## TEXAS COMMISSION ON ENVIRONMENTAL QUALITY

NAME OF PROJECT: **Vintage Oaks at the Vineyard, the Reserve**; Located approximately 0.49 miles north of Via Principale and State Highway 46 intersection; New Braunfels, Texas

TYPE OF PLAN: Request for Approval of a **Water Pollution Abatement Plan (WPAP)**; 30 Texas Administrative Code (TAC) Chapter 213 Edwards Aquifer

On September 10, 2015 we received comments on the WPAP review. The following revisions have been made in response to the comments:

VINTAGE OAKS AT THE VINEYARD, THE RESERVE  
SITE PLAN

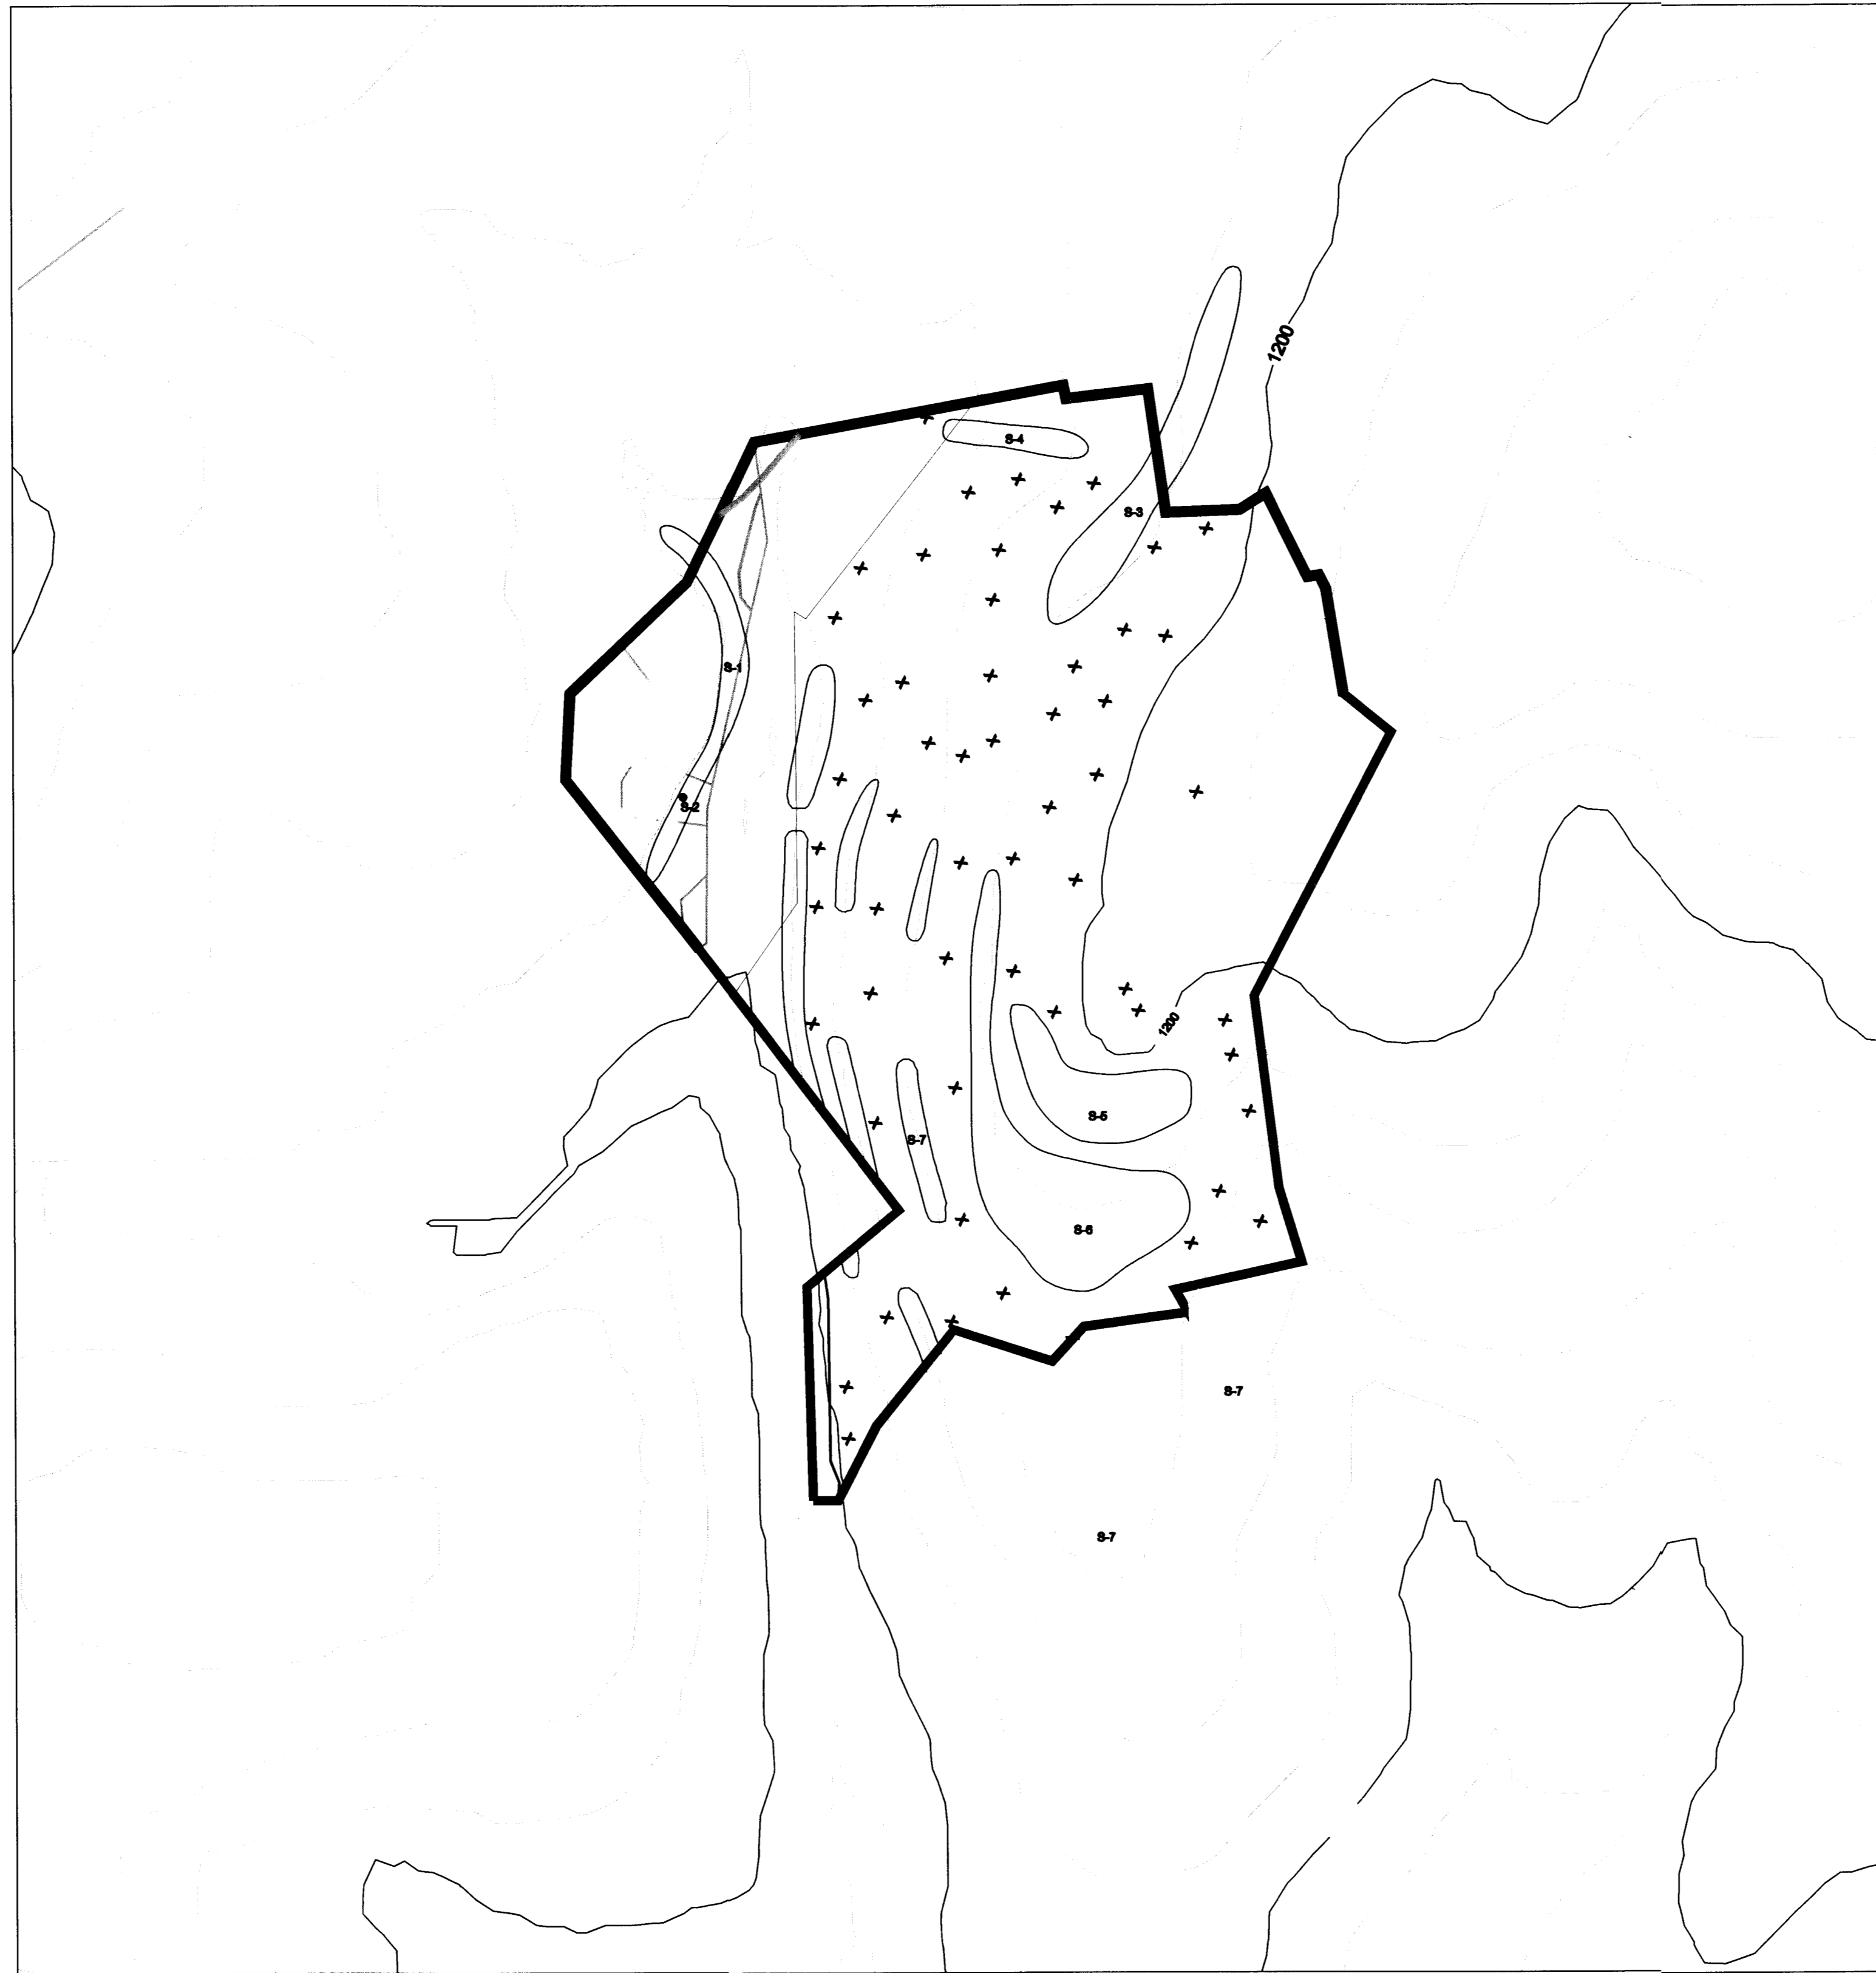
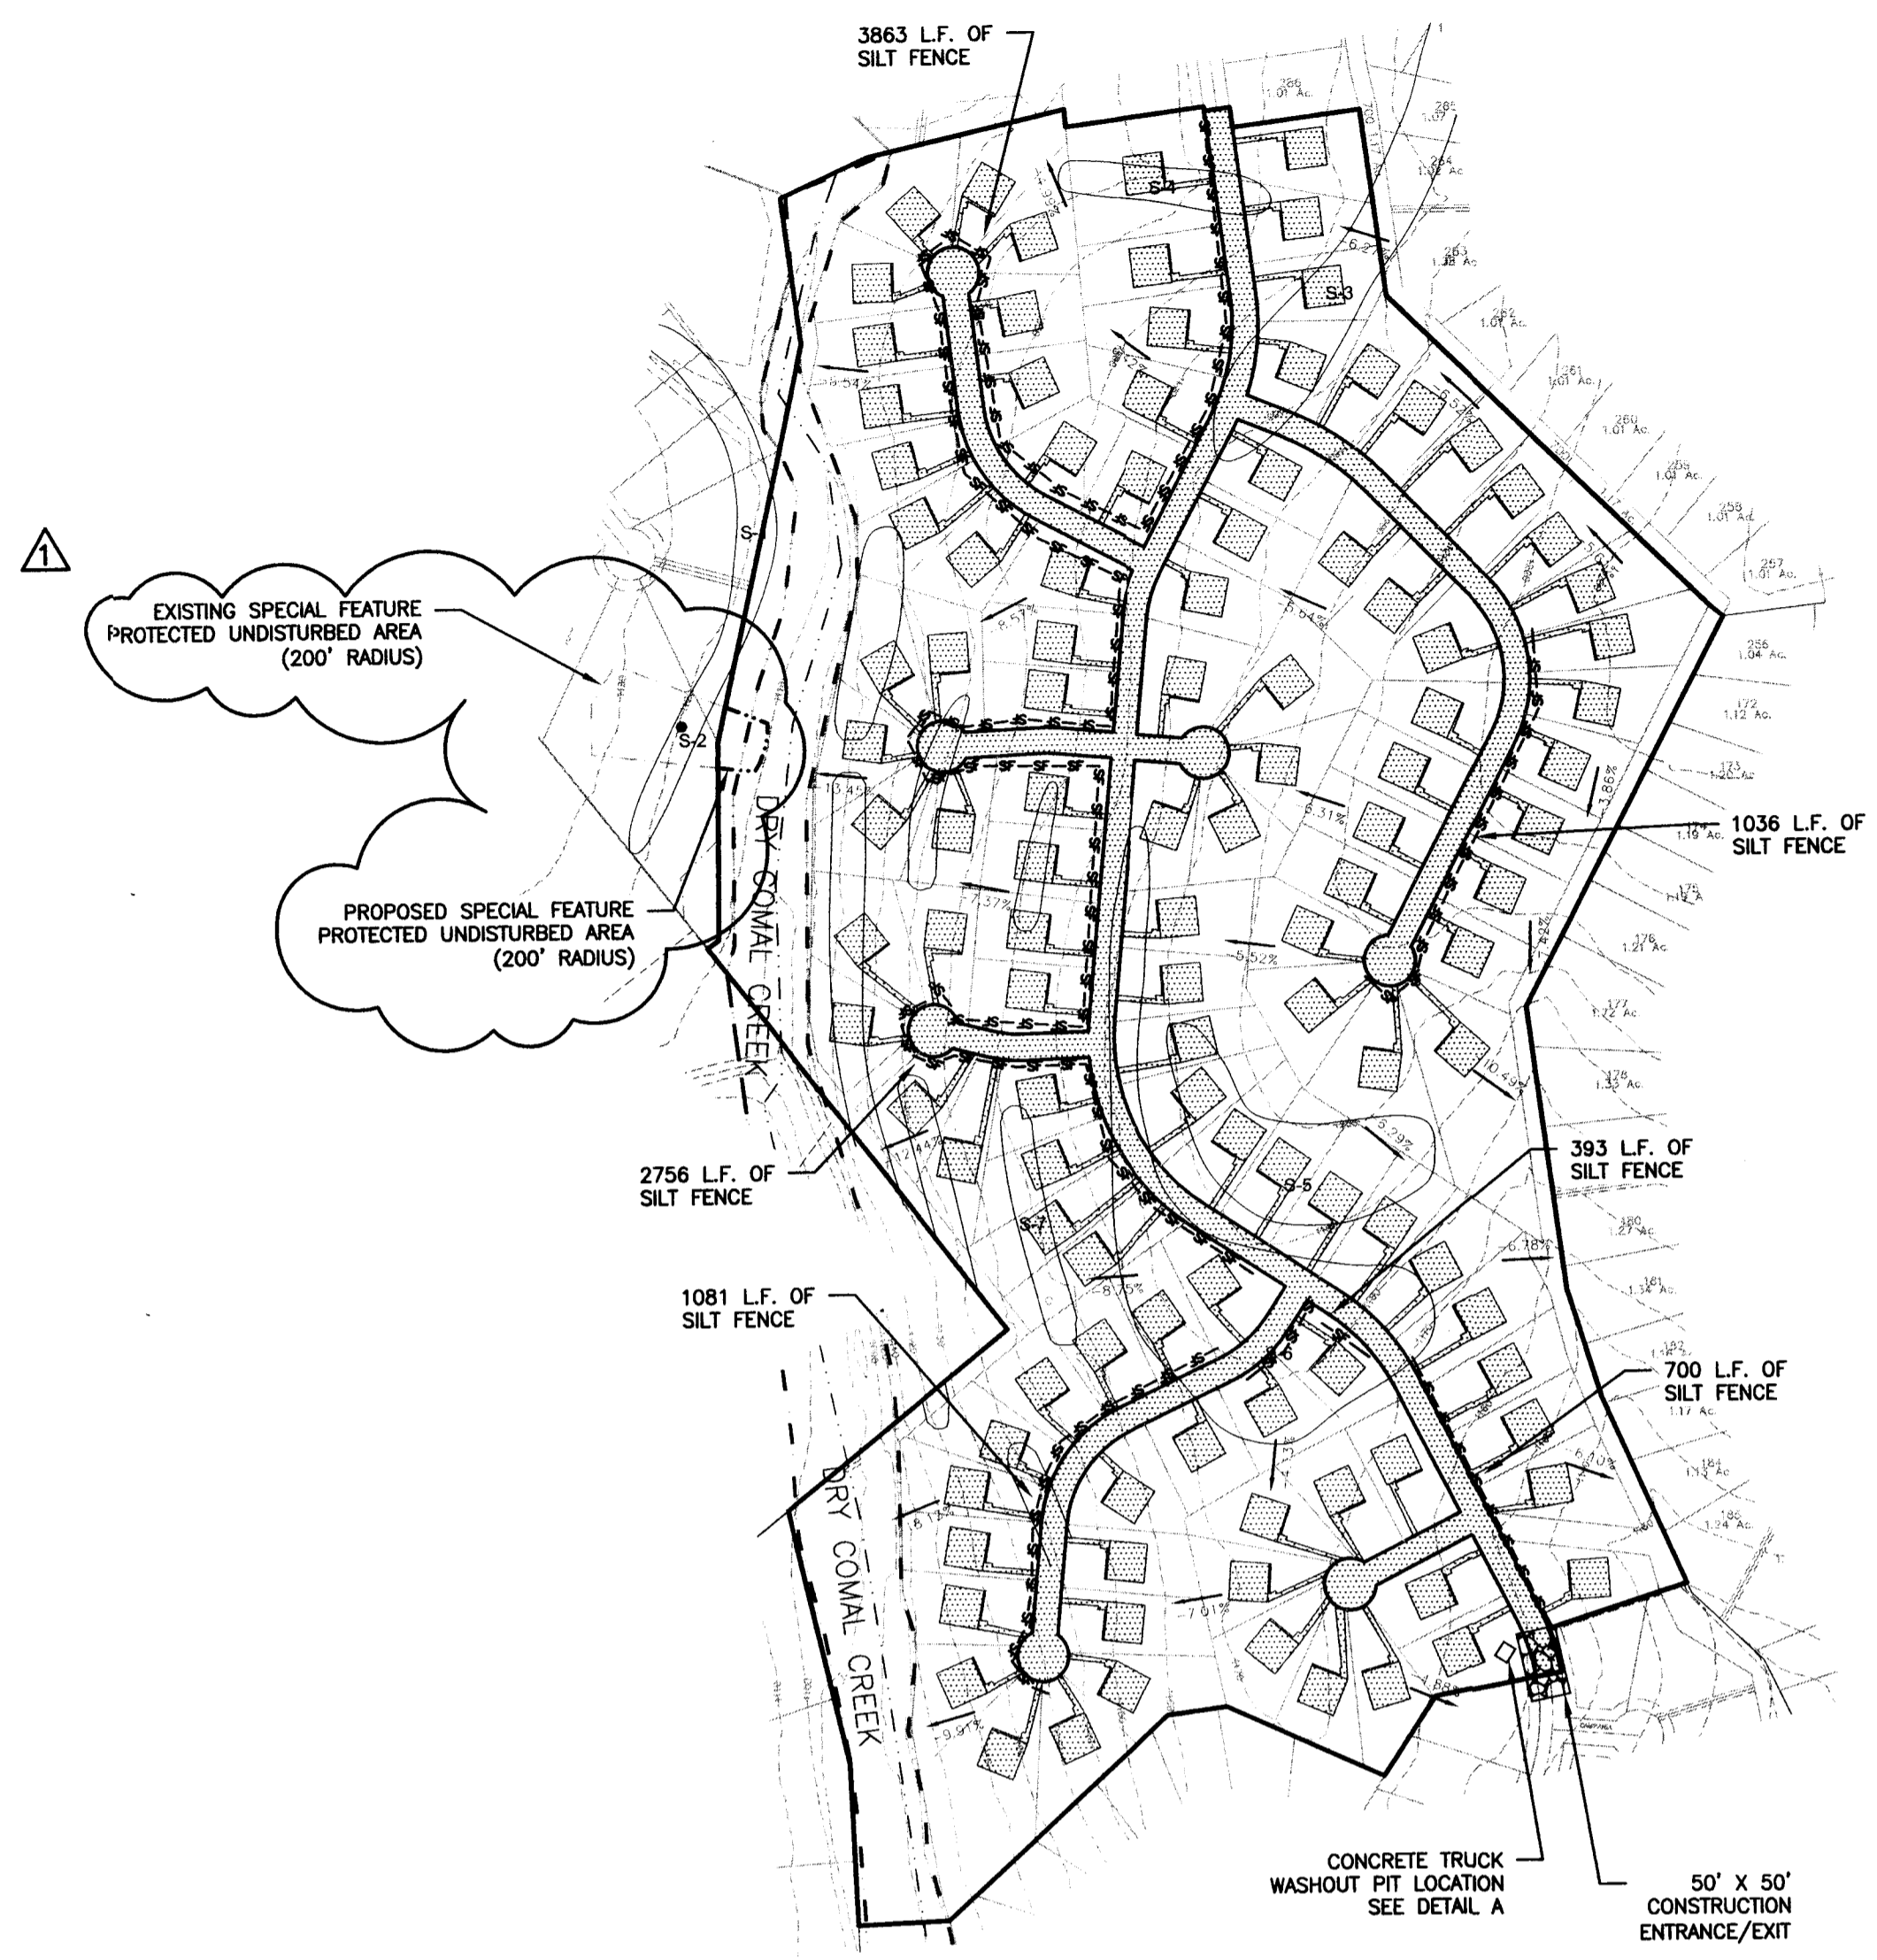
3. Please show drainage area for sensitive feature S-2. If the drainage area to the feature lies more than 50 feet from the feature (rim of the sinkhole bowl), the buffer should extend to the boundary of the drainage area or 200 feet, whichever is less. Please show new buffer for S-2 on Sheet 1 as well as in text found throughout the application (Project Description and Temporary Stormwater Section Attachment D).

Response: There is currently a 200 foot boundary that was placed in Unit 6 of the Vintage Oaks at the Vineyard Subdivision. The boundary was extended into the Reserve unit of the subdivision and follows the 200 foot boundary rule. The correction

has been made on Sheet 1, the Project Description, and the Temporary Stormwater Section Attachment D.

REVISIONS:	
DELTA	DESCRIPTION
1	ADDED EXISTING AND PROPOSED 200' BOUNDARY FOR SPECIAL FEATURE

1. Geologic Site Plan scale does not match Site Plan, please correct.

Response: The Geologic Site Plan was scaled to match the Site Plan's scale of 1'=400 and printed on the correct size paper (24"X36").
